Planning, Land Use and Mobility Committee

Case Report

Case Nos: DIR-2021-6097-DRB-SPP-MSP
ENV-2021-6098-CE

Site Location: 4343 N. Divina St., Woodland Hills, 91364

Elevations revised 4/22/22 showing sloping sections of the roof instead of flat

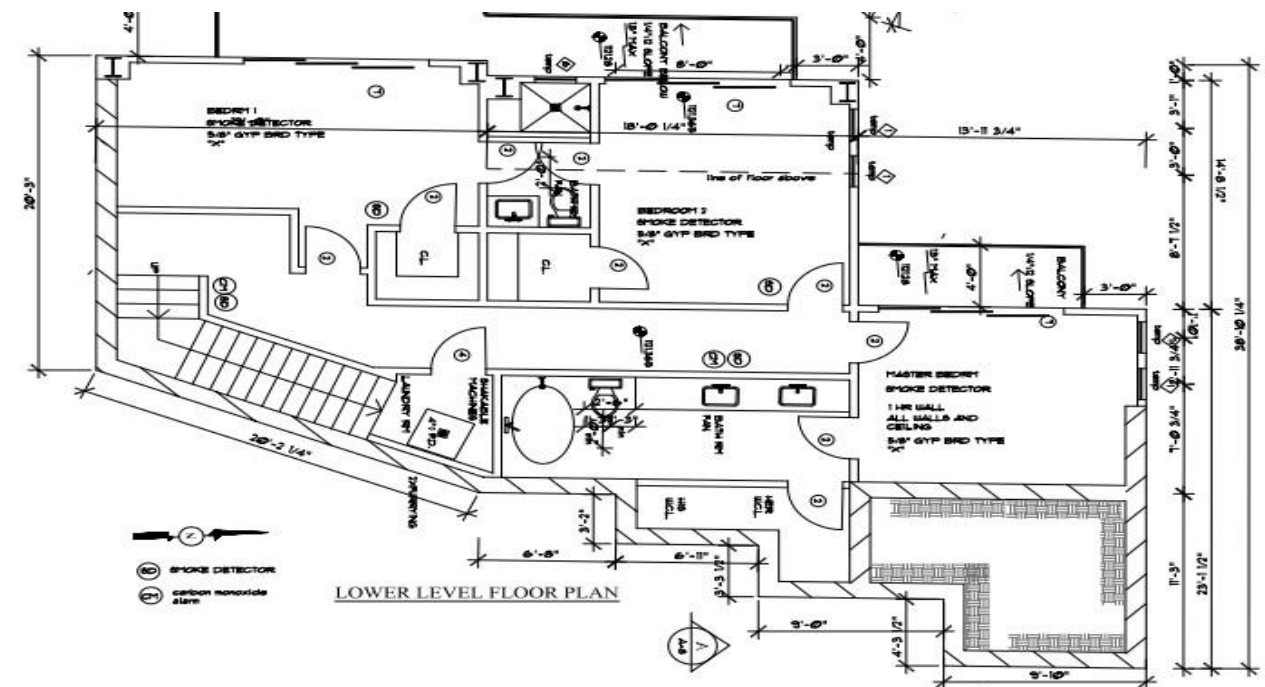
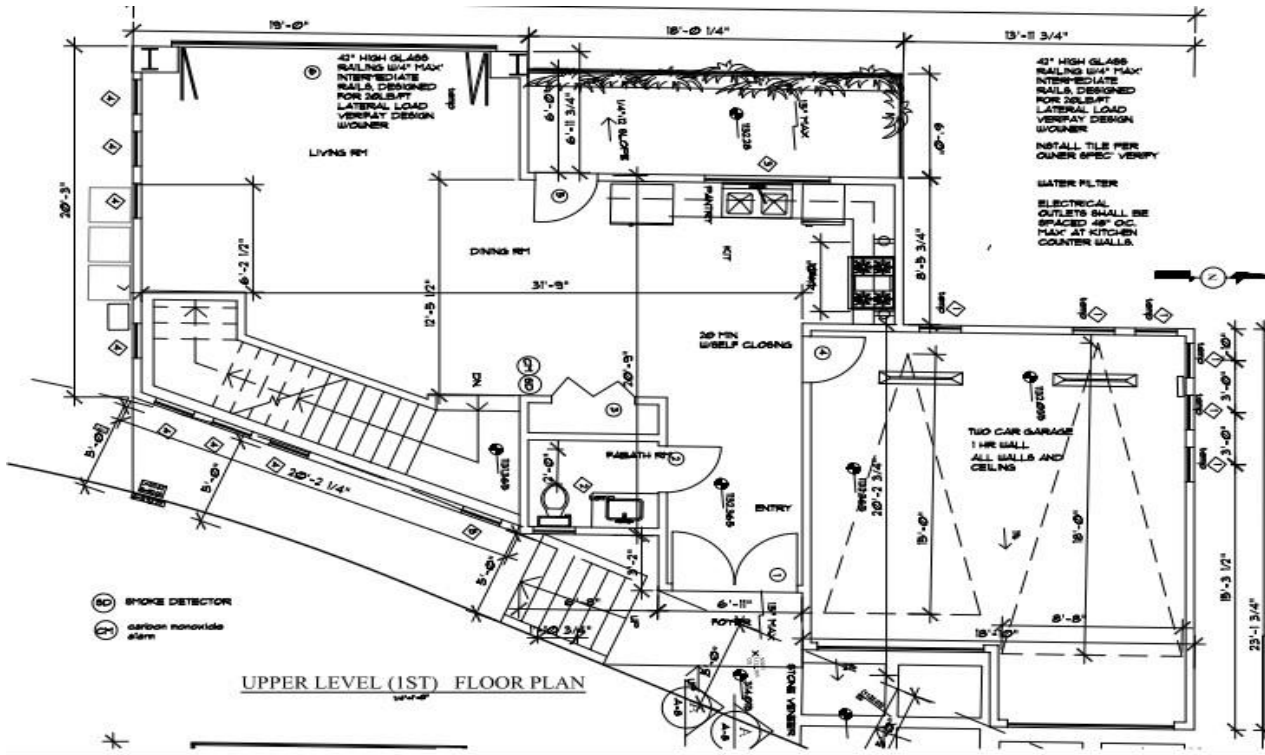
3. The PLUM committee strongly recommends the applicant provide additional articulation of the west elevation with a variation of finish materials (Note: Revised elevations have been submitted to the PLUM committee on 4/22/22 reflecting this revision to the building design and are part of the Final PLUM Case Report).

4. The applicant will review the possibility and revise the flat roofs to sloping roofs if possible. (Note: Revised elevations have been submitted to the PLUM committee on 4/22/22 reflecting the revision of the building design and are part of Final PLUM Case Report).
